STAFF REPORT

CITY OF COLUMBUS PLAN COMMISSION (September 14, 2016 Meeting)

Docket No. / Project Title: PUDF-16-09 (Fairfield Inn & Suites)
Staff: Melissa Begley

Fairfield Inn & Suites is requesting to modify their previously approved Final PUD Plan for Lot 7B of Columbus Crossing. They are proposing to increase the size of the conference space, add 10 additional parking spaces and change the ground floor exterior material from EIFS to cultured stone.

SHEET
L101
 OF
 11

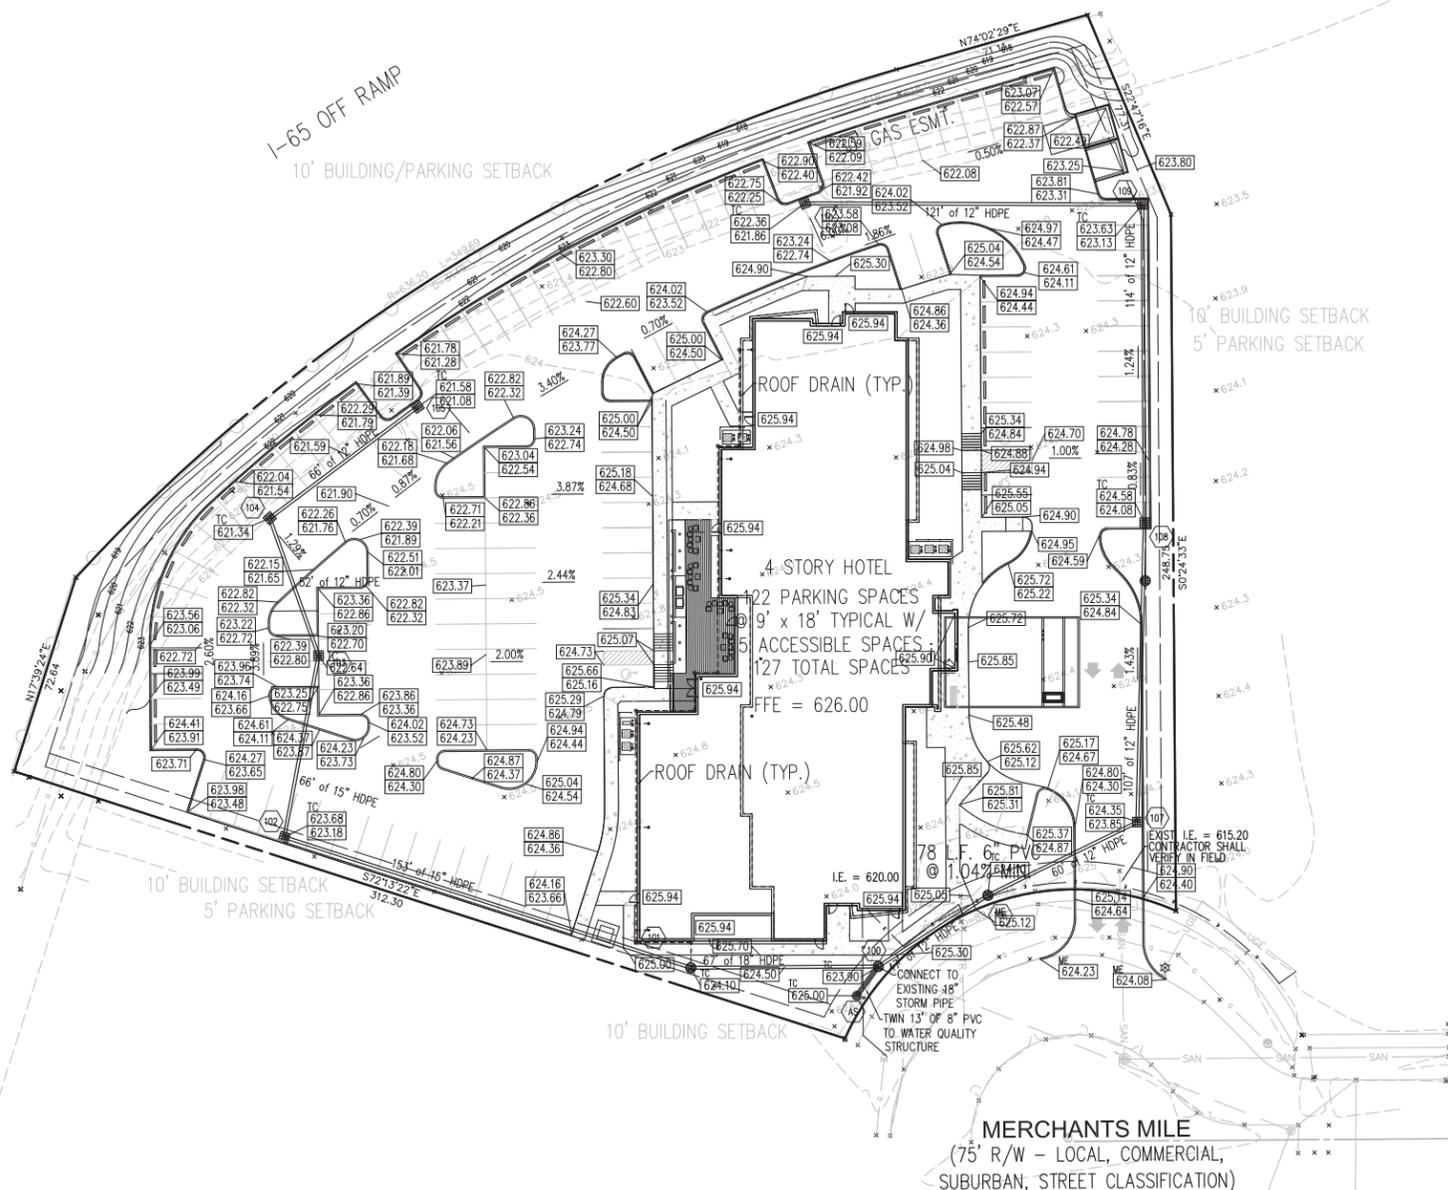
1. Provide revised landscape calculations in the Planting Calculation Table for Area #2 – Parking Lot Interior and Area #4 - Lot Interior Foundation Plantings Landscaping.
2. Provide the lighting cut sheets on the lighting plan and revise the lighting so that it does not exceed 0.1 foot candles at the PUD boundary.
3. Update the index on the cover page to reflect the actual pages in the site plan package. Omit pages 104 and 802 from the plans and include color elevations for the North and West facades.

REVISIONS:
 1- METAS PERM. BASIS PLAN SHEET HAS PLANNING CALCULATION TABLE PER COMMENT
 2- 4-7-14-RE-REVISIONED PAVING
 3- 8-9-16-RE-REVISIONED PAVING
 4- 8-9-16-RE-REVISIONED INTERIOR SPACE CALC. PER COLUMBUS COMMENT
